RESPONSE TO SUBMISSIONS AND PREFERRED PROJECT REPORT - ST ANTHONY OF PADUA CATHOLIC SCHOOL (SSDA_8865)

EXECUTIVE SUMMARY

This “Response to Submissions” Report (**RtS Report**) addresses the issues raised in community and stakeholder feedback received during the exhibition of the environmental impact statement (**EIS**) for the proposed St Anthony of Padua Catholic School (the Proposal) at 125-165 Tenth Avenue and 140-170 Eleventh Avenue, Austral (**SSD DA_8865**). This report has been prepared by Urbis Pty Ltd on behalf of Sydney Catholic Schools (**SCS**) (**the applicant**).

Figure 2 – Revised site layout with original building footprint overlaid

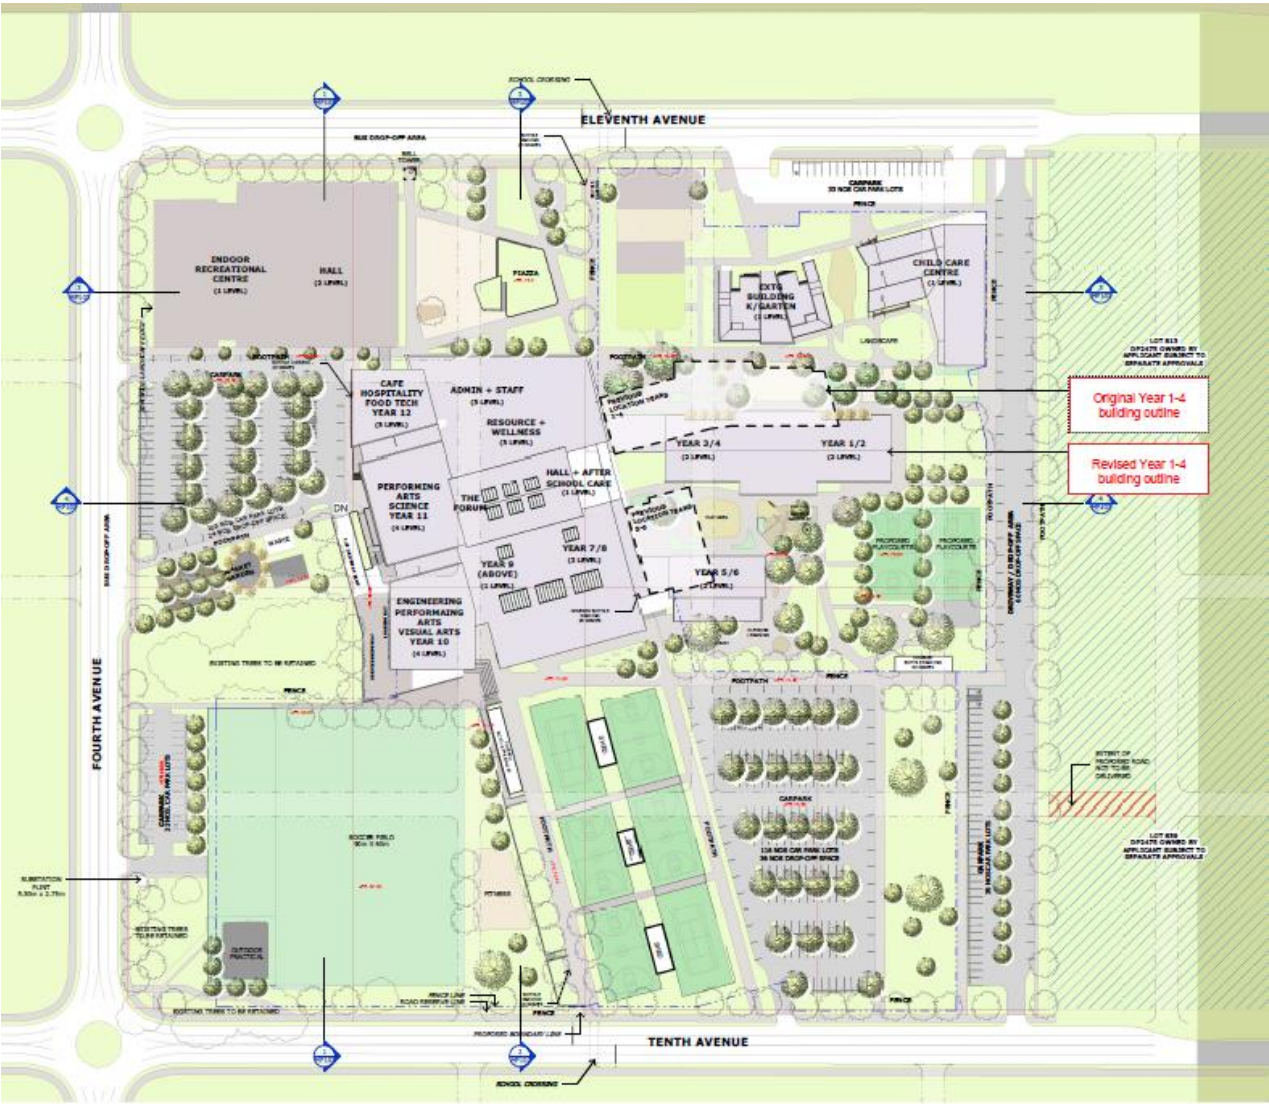
- Re -orientation of the Year 1-4 and Year 5-6 building;
- Update of the landscape design between and around the buildings; and
- In response to comments provided in relation to the Urban Heat Island, the proposed roofing colour has been amended to a light grey (Colorbond 'Shale Grey' or similar).

The change to the building layout has arisen from the desire to improve the efficiency and experience of the outdoor play spaces surrounding the school buildings. The amended layout has been informed by the requirements of the Catholic Schools educational specification and pedagogy.

The revised site plan with the original building location overlaid is shown in **Figure 2** below.
